INTERNAL MEMORANDUM

OBSERVATIONS BY THE ENGINEERING AND HIGHWAYS DIVISION IN RESPECT OF DEVELOPMENT AFFECTING EXISTING OR PROPOSED PUBLICLY MAINTAINED HIGHWAY

Change of use from a dwelling (C3) and two-storey rear extension to provide a children's care home (C2)

16, Gelligaer Road, Trelewis, Treharris, Merthyr Tydfil, CF46 6DN

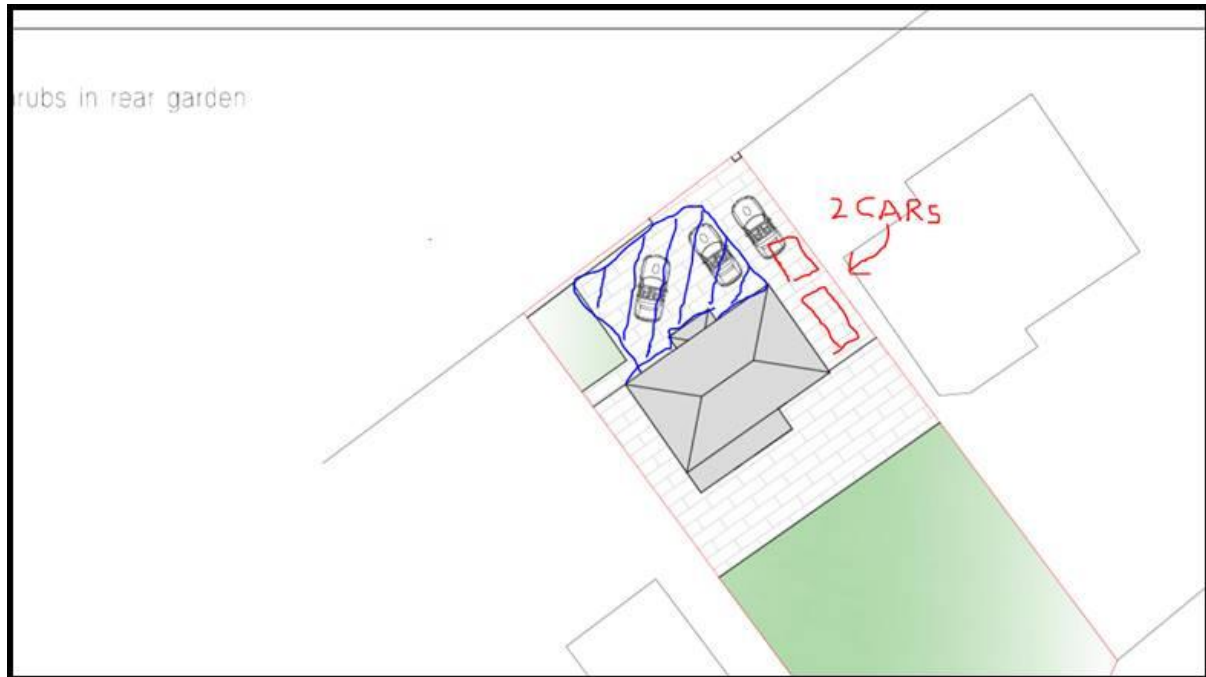
The property is adjacent to a “B road” which is classified. Due to this, cars must be able to leave the driveway in a forward gear meaning they need to be able to turn on the driveway/parking area before exiting. Therefore, there appears to only be enough space for 2no vehicles to park in tandem as shown in red below, and then the turning area marked in blue should be kept clear in order for vehicles to turn and exit in a forward gear.

For the existing use of the building, there are 4no existing bedrooms and 2no existing off-street parking spaces available. As there is no increased requirement for additional parking the existing 2no spaces are acceptable, however this should be re arranged as per the above diagram where 2no cars park in tandem and there is enough space for a vehicle to turn

- 1) Prior to the development being brought into use, a turning area to enable vehicles to enter and leave the site in a forward gear shall be shown in accordance with details, which have been submitted to and approved in writing by the Local Planning Authority before any development commences on site.
